Changelog:

Chrysler CCD/SCI Scanner	
ChryslerCCDSCIScanner_V144	
2020. 12. 08. 18:06	László Dániel
Sheet: 1/1	A2 Rev: V1.44

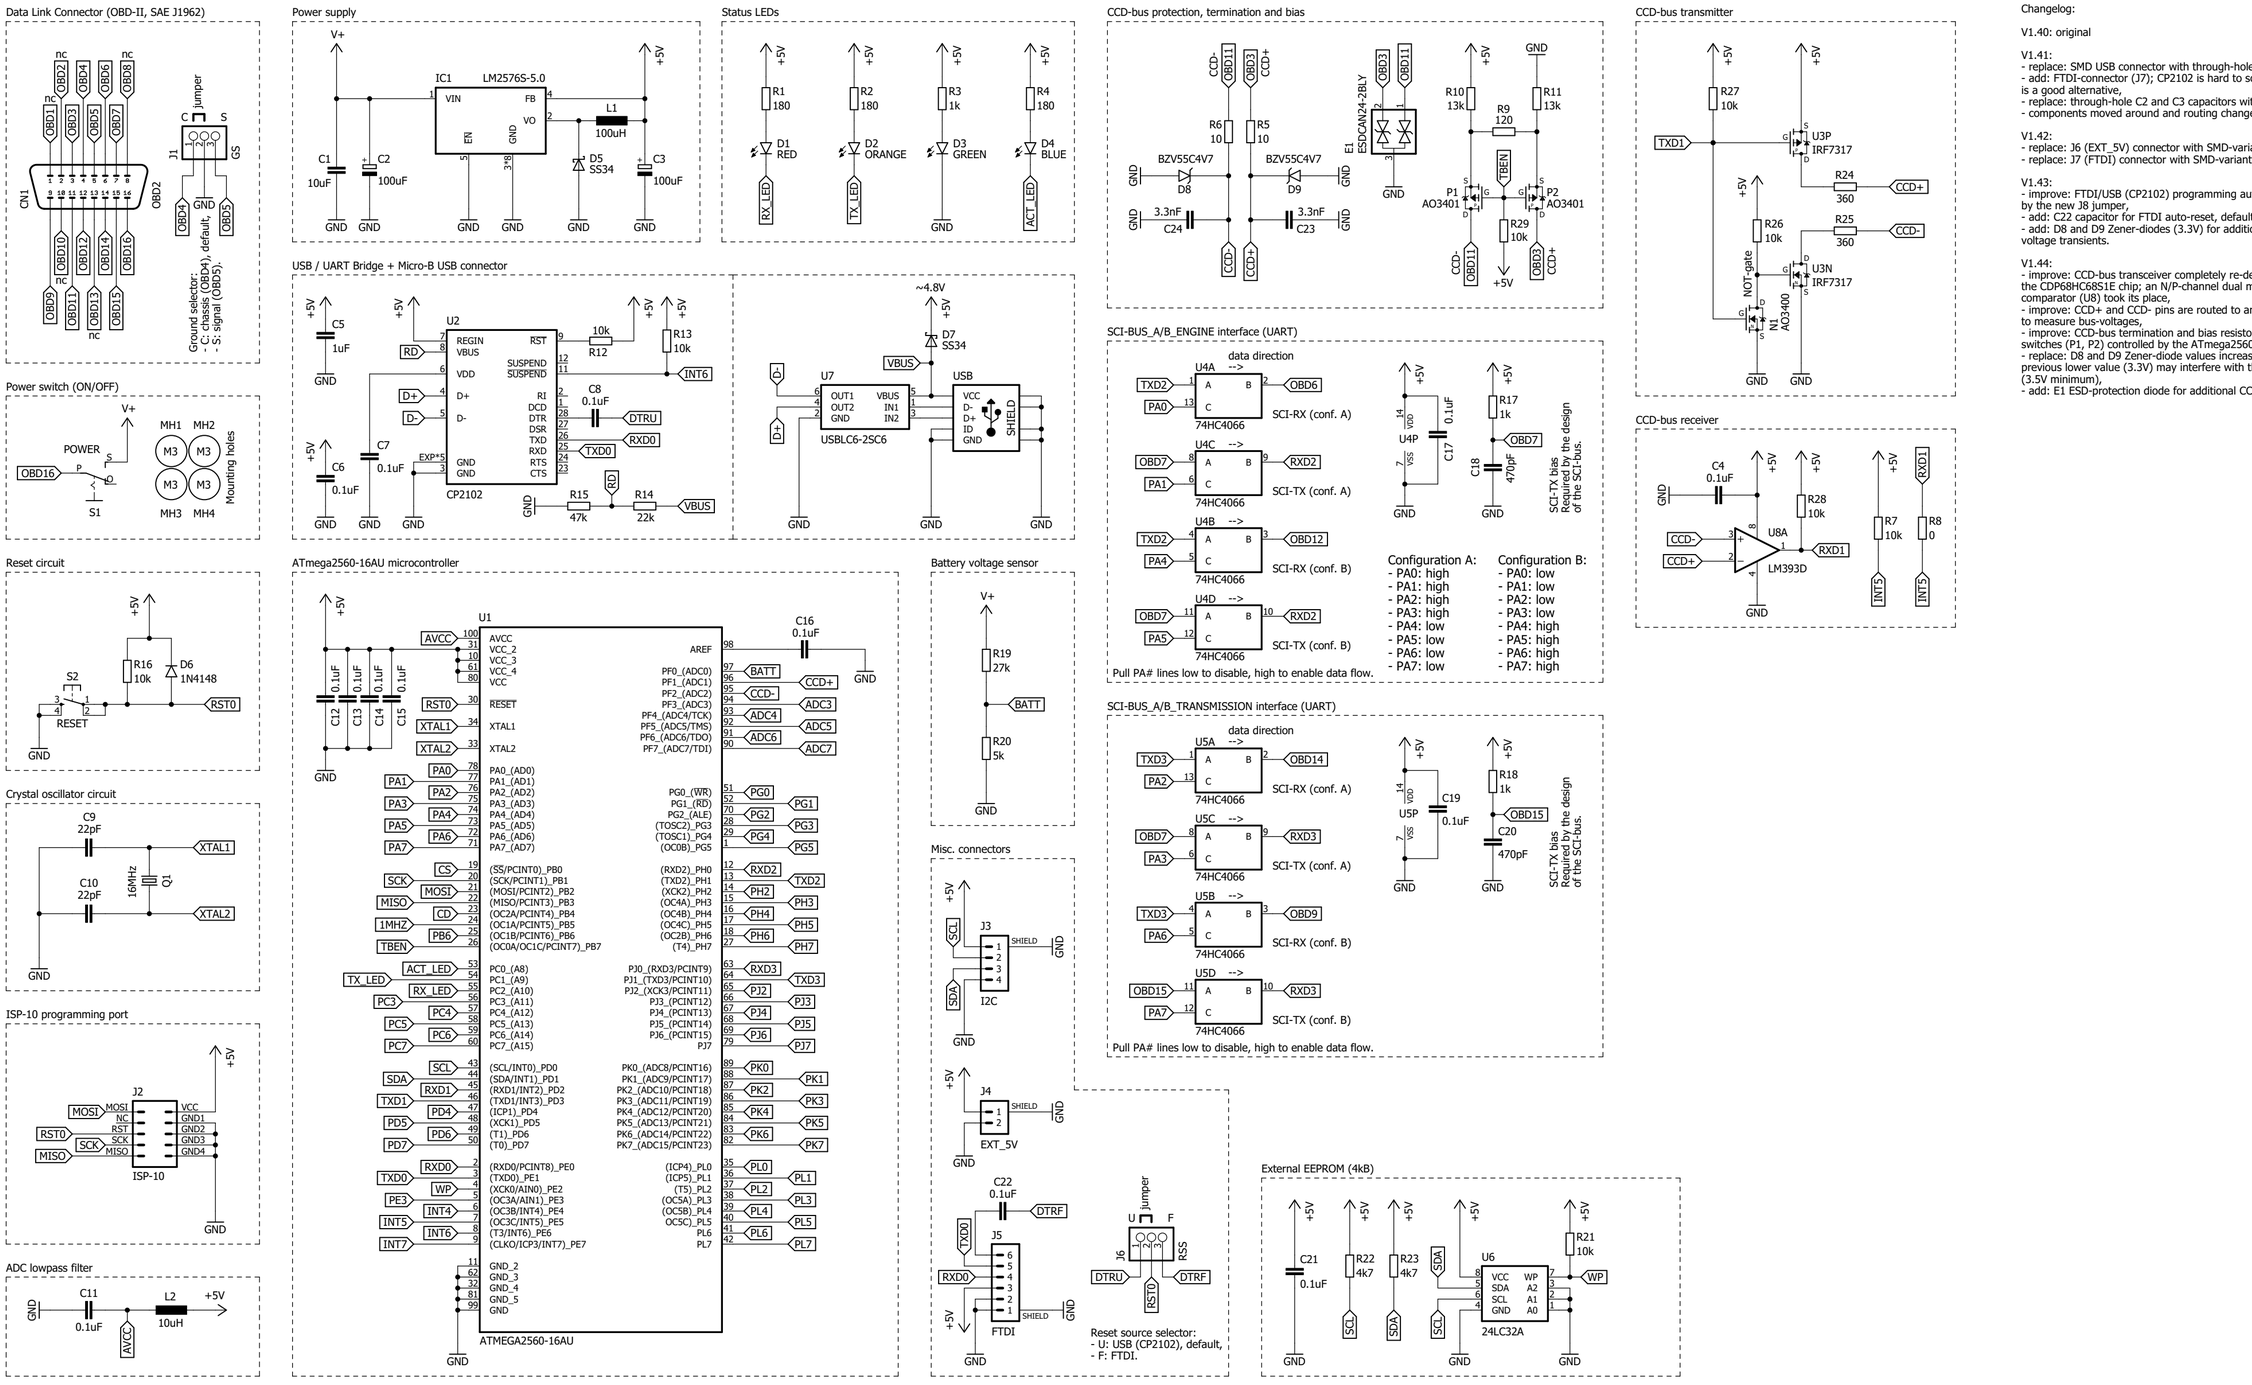
V1.41:
- replace: SMD USB connector with through-hole variant,
- add: FTDI-connector (J7); CP2102 is hard to solder, FTDI programming is a good alternative,
- replace: through-hole C2 and C3 capacitors with SMD-variant,
- components moved around and routing changed to optimize layout.

V1.42:
- replace: J6 (EXT_5V) connector with SMD-variant,
- replace: J7 (FTDI) connector with SMD-variant.

V1.43:
- improve: FTDI/USB (CP2102) programming auto-reset circuit is selectable by the new J8 jumper,
- add: C22 capacitor for FTDI auto-reset, defaults to USB (CP2102) auto-reset,
- add: D8 and D9 Zener-diodes (3.3V) for additional CCD-bus protection against voltage transients.

V1.44:
- improve: CCD-bus transceiver completely re-designed and it no longer uses the CDP68HC68S1E chip; an N/P-channel dual mosfet (U3) and voltage comparator (U8) took its place,
- improve: CCD+ and CCD- pins are routed to analog inputs of the ATmega2560 to measure bus-voltages,
- improve: CCD-bus termination and bias resistor jumpers replaced by P-MOSFET switches (P1, P2) controlled by the ATmega2560,
- replace: D8 and D9 Zener-diode values increased to 4.7V; previous lower value (3.3V) may interfere with the CCD-bus wake-up signal (3.5V minimum),
- add: E1 ESD-protection diode for additional CCD-bus protection.
